Addendum No. 01

SUBJECT: OR22: Center St Bridge (Phase 1) Project
Willamina-Salem Highway
Marion & Polk Counties
Grading, Drainage, Structures, Paving, Signing, Illumination, And Roadside
Development
(Bids Closing September 22, 2026)

CONTRACT NO.: 15659 **PROJECT:** OR22: CENTER ST BRIDGE (PHASE 1)
PROJECT KEY: 21705 **ADDENDUM NO.:** 1

SIDE MOUNT DETAIL 1
Scale: 3/4"=1'-0"

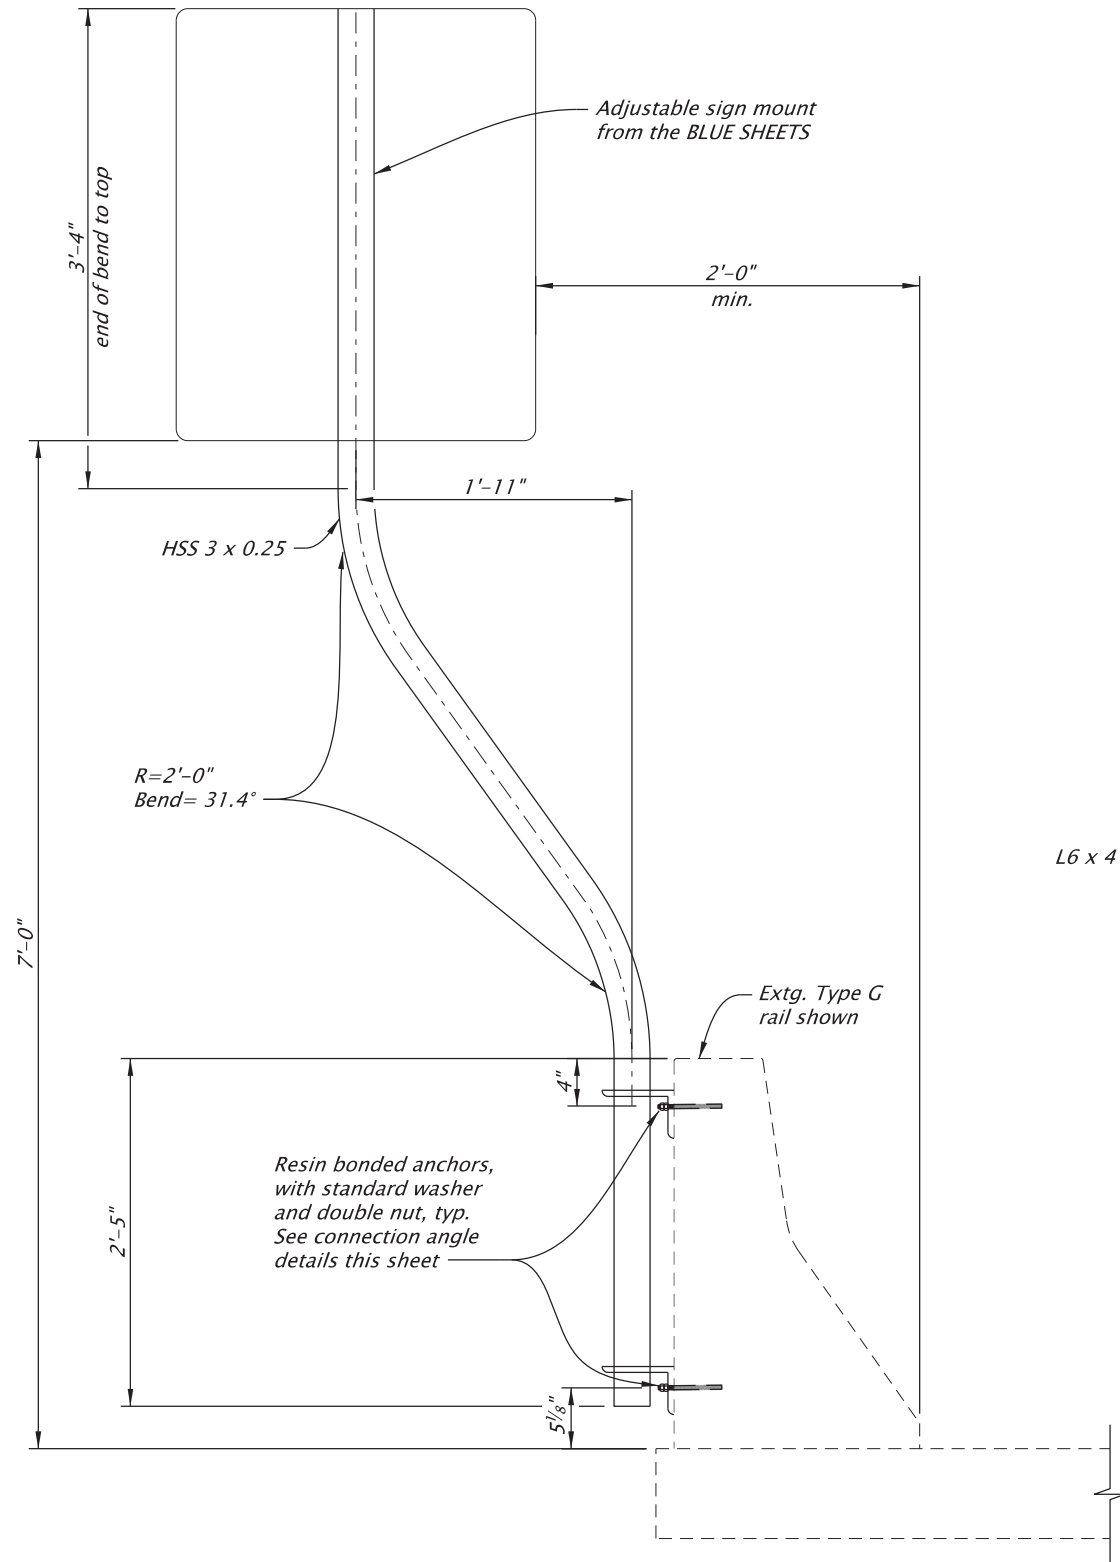
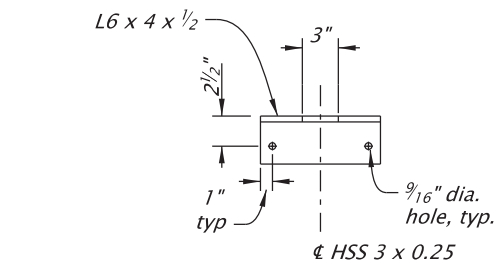
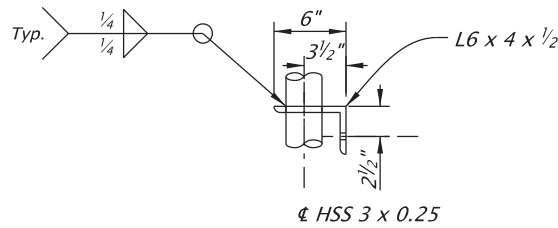
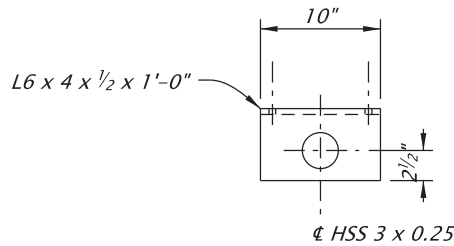
RESIN BONDED ANCHOR NOTES
Provide and install 1/2" diameter ASTM F1554 Grade 36
resin-bonded anchors with epoxy resin from the list
below. The minimum pullout strength is 7400 pounds
with a minimum effective embedment (hef) of 5 inches

No.	DATE	REVISIONS	BY
1	08-17-26	Addendum 01 (sheet added)	JEKP

SHEET NO.
LA01

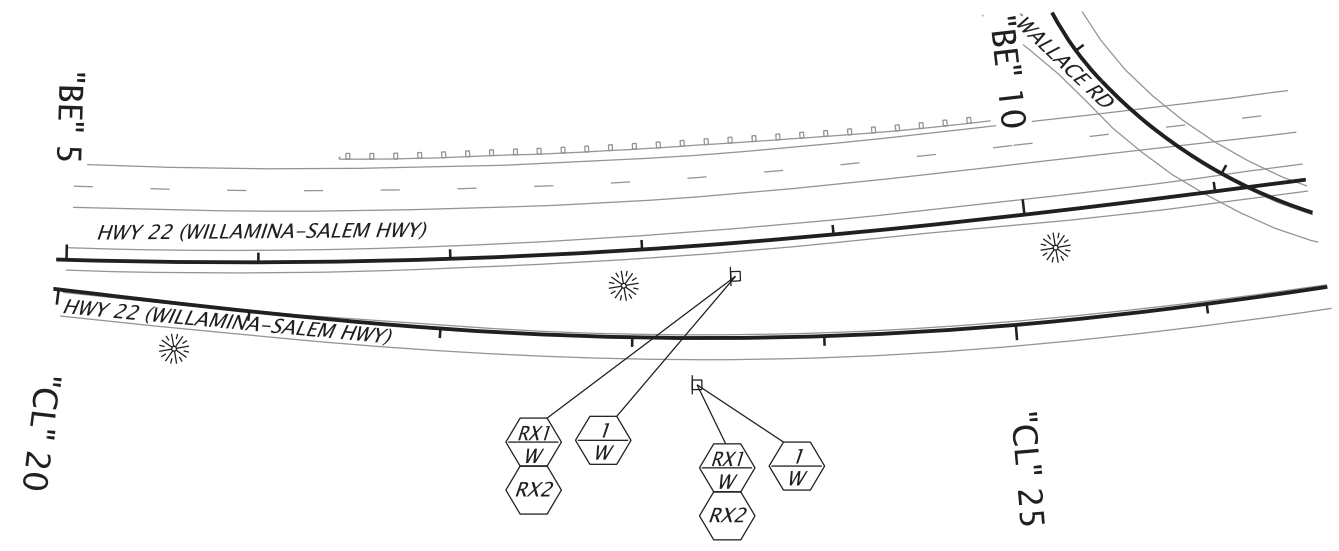
- Install new sign (N)
- Install new sign (N) on new (M) sign support
- Maintain and protect existing sign (N) and support
- Remove existing sign (N) and (M) sign support
- Remove existing sign (N)
- See Sheet LC01 for attachment and support information

No.	DATE	REVISIONS	BY
	08-14-26	Added Sheet LA01	G.F.
